<b>SUNDRY NOTICES AND REPORTS ON WELLS</b> (DO NOT USE THIS FORM FOR PROPOSALS TO DRILL OR TO DEEPEN OR PLUG BACK TO A DIFFERENT RESERVOIR. USE "APPLICATION FOR PERMIT" (FORM C-101) FOR SUCH PROPOSALS.) 1. Type of Well: Oil Well <input checked="" type="checkbox"/> Gas Well <input type="checkbox"/> Other <input type="checkbox"/>		WELL API NO. 30-005-29028

NMOCD plans to plug this well in accordance with the attached procedure and any agreed modifications there to.

### **Plug And Abandonment Procedure**

#### **Cato San Andres #822**

## Proposed Wellbore Diagram

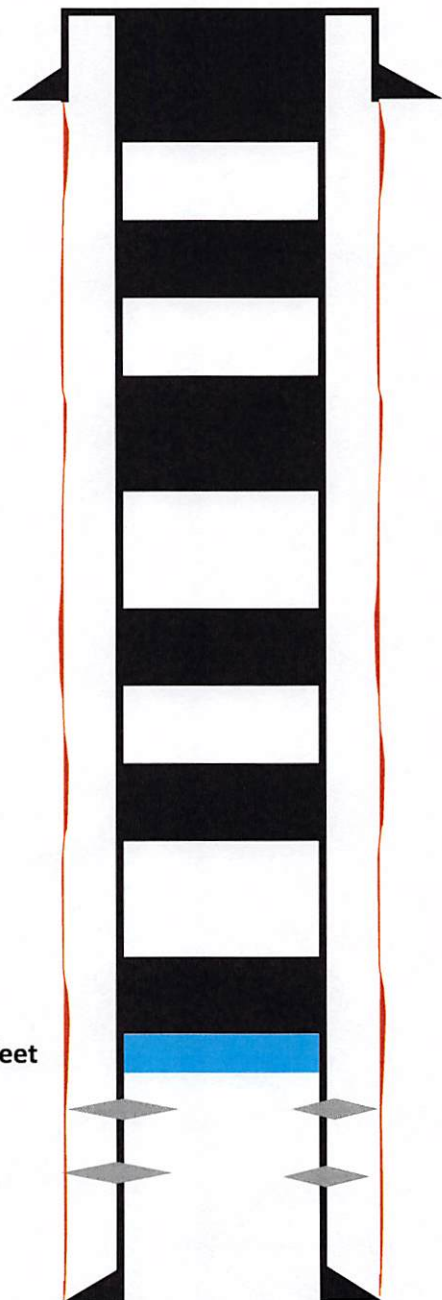
**APPROVED WITH CONDITIONS**

Perf & Sqz all  
 plugs where no  
 cmt behind pipe.

Perf & Sqz all csg  
 shoes.

Adhere to NMOCD  
 COAs attached.
